**Maharashtra State  
Road Development  
Corporation Limited**

**MSRDC/02/JMD(ENGG-I)/Revas-Reddi/Agardanda/  
Date :- 15.02.2024.**

**Sub :** RFP for construction of Two-Lane Bridge across Agardanda Creek with approaches Connecting Agardanda Tq. Murud and Dighi Tq. Shrivardhan In Raigad District on Revas-Redi Coastal Highway (Msh-04) In the State of Maharashtra on EPC Mode.

**Common Set of Clarification**

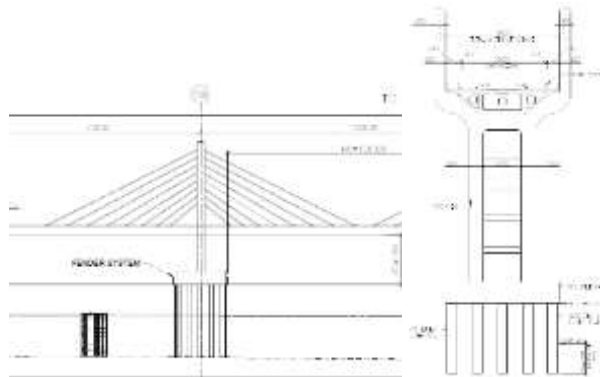
5	Volume III, Technical schedule	General arrangement drawing Page no....	Drawing no: Coastal Road Package II/ GAD/Agardanda creek bridge shows span arrangement 36 spans x 50m + 1 span x 65m + (75m+120m+120m+75m) + 1 span x 65m + 36 spans x 50m	We presume that the navigational span configuration of (75m+120m+120m+75m) is mandatory and the span length of 65m adjacent to navigation span is not mandatory. The min span length for non-navigation spans shall be not less than 50m. Please confirm if our understanding is correct.	The navigational span configuration of (75m+120m+120m+75m) is mandatory and the min span length for non-navigation spans shall be not less than 50m.

TYPICAL CROSS SECTION (TCS-03 A)  
(OPEN COUNTRY SECTION PLAIN/ROLLING TERRAIN)  
TWO LANE WITH PAVED SHOULDER FOR BRIDGE AT DECK LEVEL-WITH FOOTPATH  
(AS PER FIG 7.6 OF IRC:SP:73-2018)

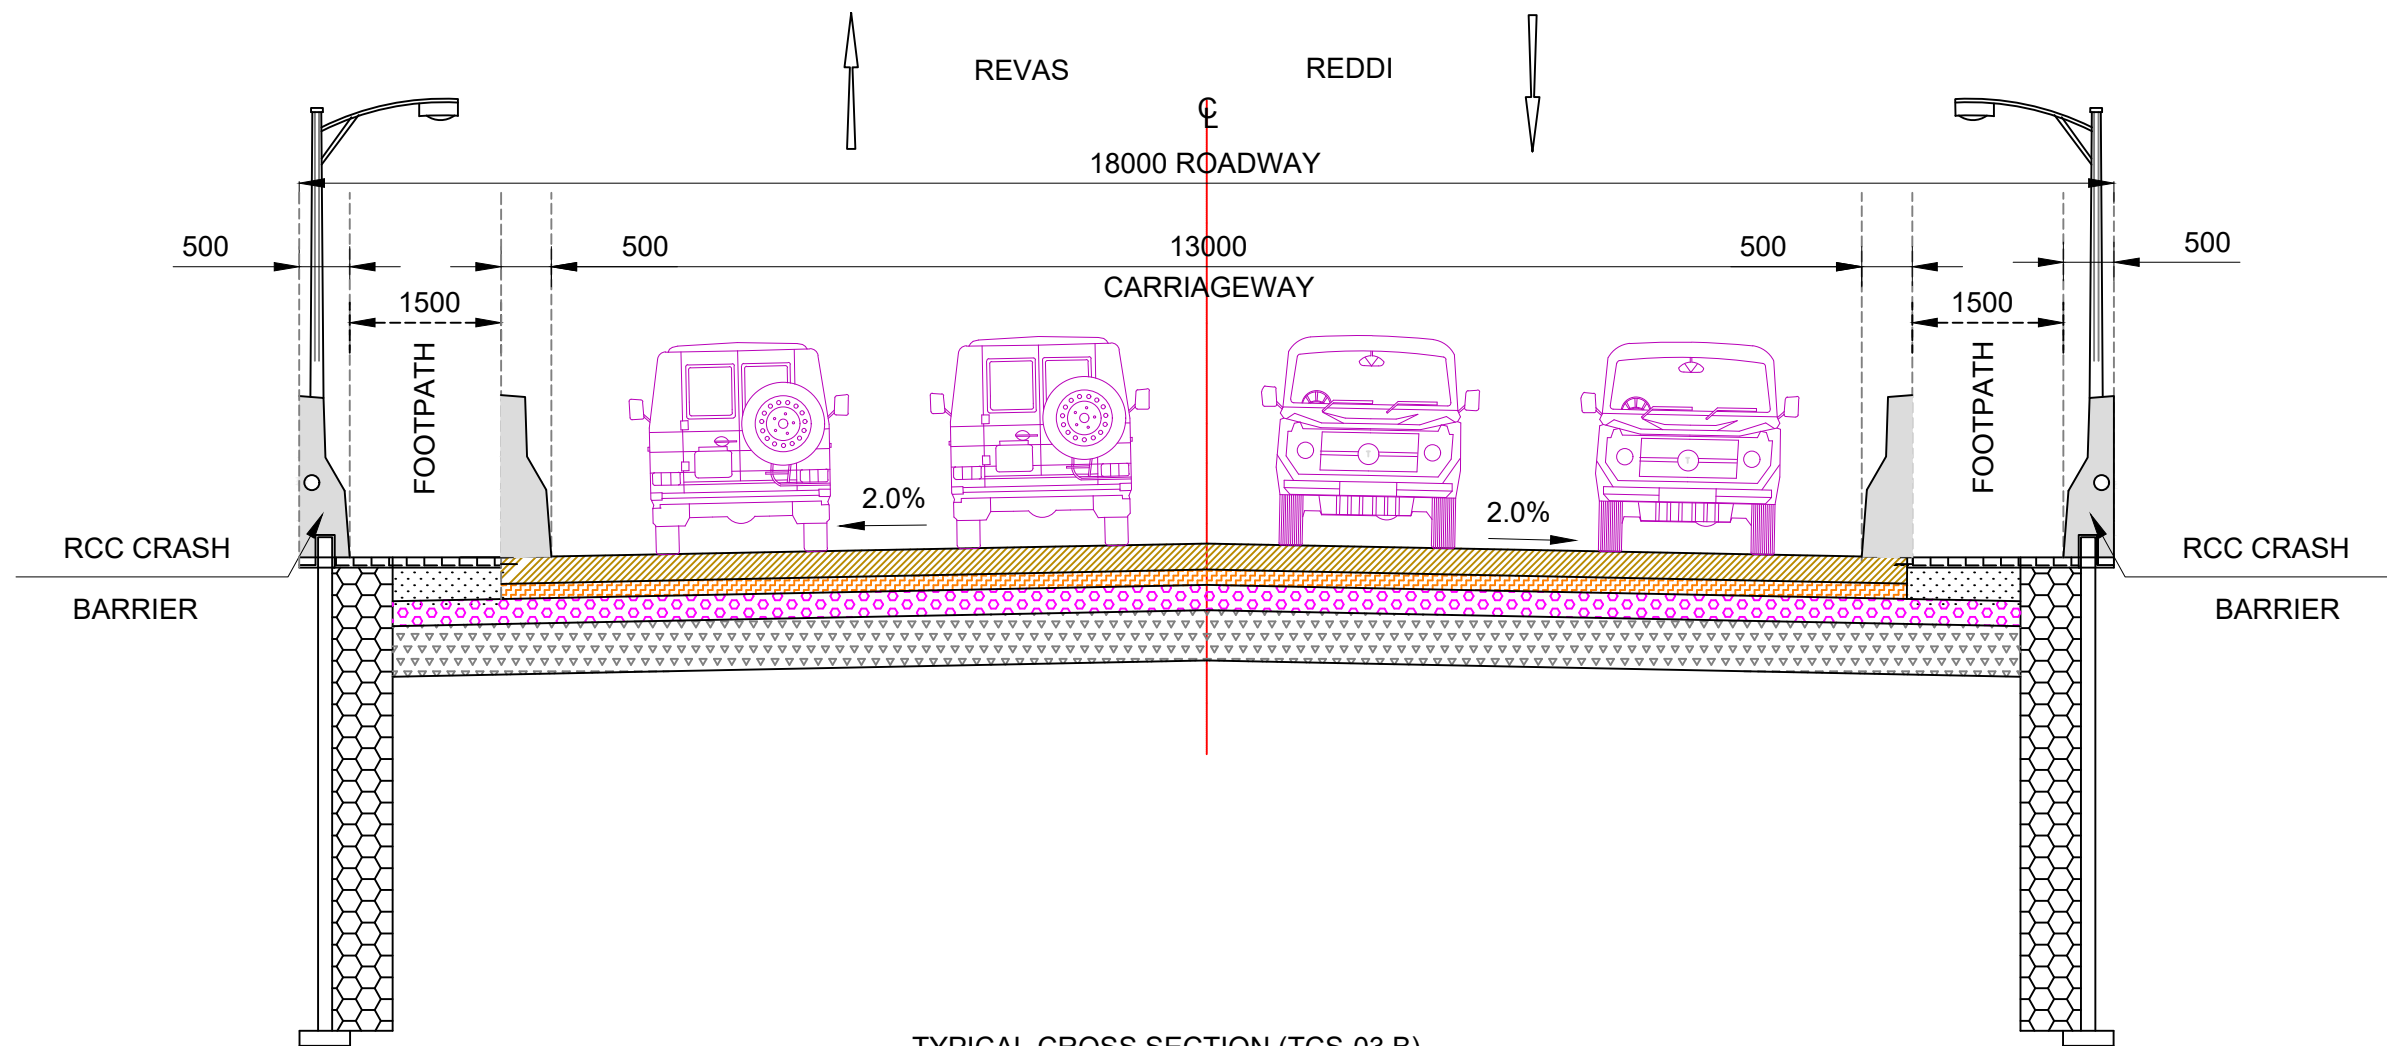
Sr. No.	Volume No.	Document / Section/ Article and Clause /Sr. No, Page no.	Clause Description	Queries Raised by bidder	Reply/ Clarification
23.		Volume III, Schedule B, page no. 24 TCS 03A	<p>The Bridge includes Approaches with 1.5 m wide protected Footpath on both sides separated by Metal beam Crash Barrier from Carriageway and RCC crash barrier on both side of roadway. TCS-03 A drawing.</p> 	As per TCS-03 A metal barrier is located between Footpath and Carriageway & Coastal Road Package II/ GAD/Agardanda creek bridge RCC Anti-Crash Barrier is located between Footpath and Carriageway. Please review and confirm which section is to be followed.	Please refer CSD

- i) KMZ file
- ii) CAD copy of GAD of Bridge
- iii) Revised TCS R1
